## 2.4 Hydrology

To ensure that a nuclear power plant(s) could be designed, constructed, and operated on an applicant's proposed ESP site in compliance with the Commission's regulations, the NRC staff evaluates hydrology information that may affect the design and siting of such a plant. The staff has prepared Sections 2.4.1 through 2.4.13 of this SER in accordance with the review procedures described in RS-002, using information presented in SSAR Section 2.4, the applicant's responses to RAIs, and generally available reference materials, as described in the applicable sections of RS-002.

**Figure 2.4.3-4 Applicant's original (black line) and staff's conservative (red line) unit hydrographs**

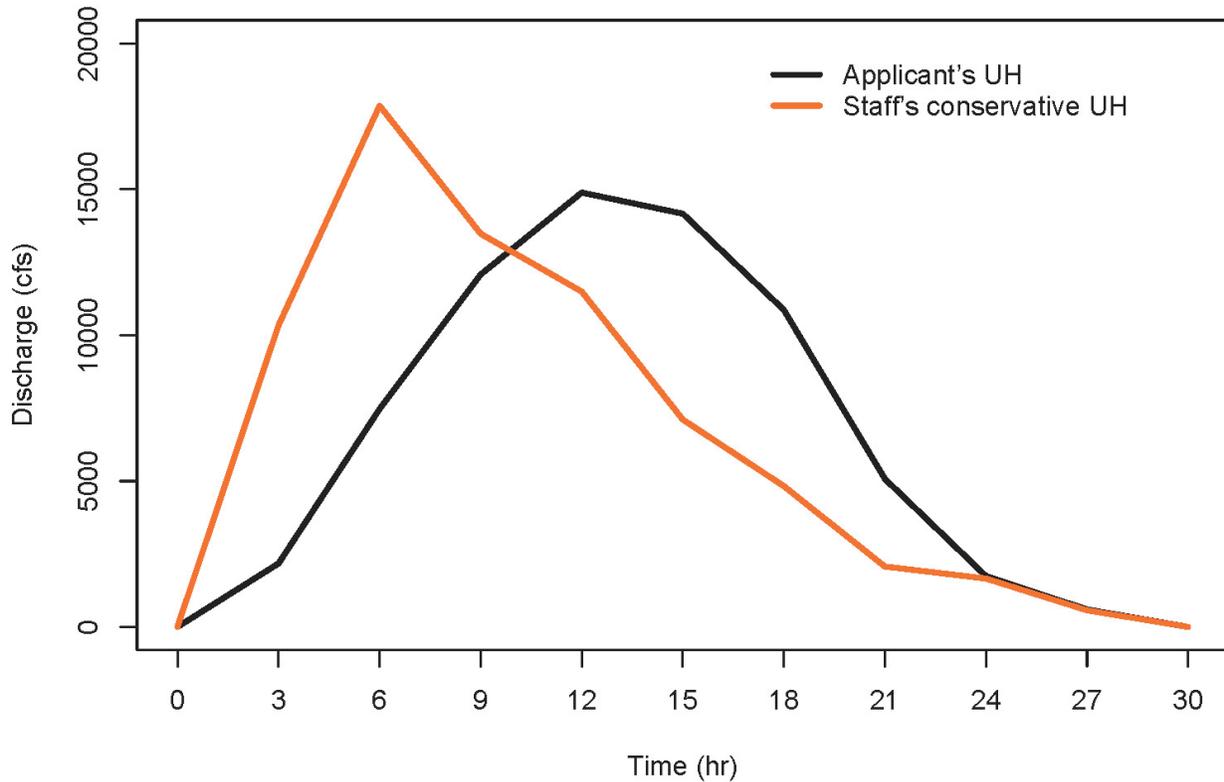
The staff also determined (Linsley, et al., *Hydrology for Engineers*, 3<sup>rd</sup> Edition, 1982; Pilgrim and Cordery, "Flood Runoff," Chapter 9 in *Handbook of Hydrology*, 1992) that for computing floods from PMP, unit hydrograph flood peaks should be increased from 5 to 20 percent, and the time to peak should be reduced to 33 percent. The staff adjusted the applicant's unit hydrograph according to these guidelines to provide a more conservative estimate. Figure 2.4.3-4 illustrates the staff's conservative and the applicant's original unit hydrographs.

The staff also conservatively assumed that no infiltration losses occurred during the PMP event. The staff modified the applicant's HEC-1 input file and carried out another HEC-1 run using the conservative unit hydrograph and no infiltration loss. This run resulted in a peak inflow of 9,697 m<sup>3</sup>/s (342,502 cfs), and a corresponding peak discharge of 4,071 m<sup>3</sup>/s (143,775 cfs). The maximum calculated water surface elevation at the dam was 80.7 m (264.6 ft) MSL.

The staff estimated the maximum water surface elevation at the ESP site by adding wave height [1.3 m (4.3 ft)] and wind setup (0.14 m (0.46 ft)] to the maximum water surface elevation at the dam [80.7 m (264.6 ft) MSL]. The staff estimated the maximum water surface elevation at the ESP site to be 82.14 m (269.5 ft) MSL. This conservatively estimated maximum water surface elevation at the ESP site is 0.46 m (1.5 ft) below the plant grade.
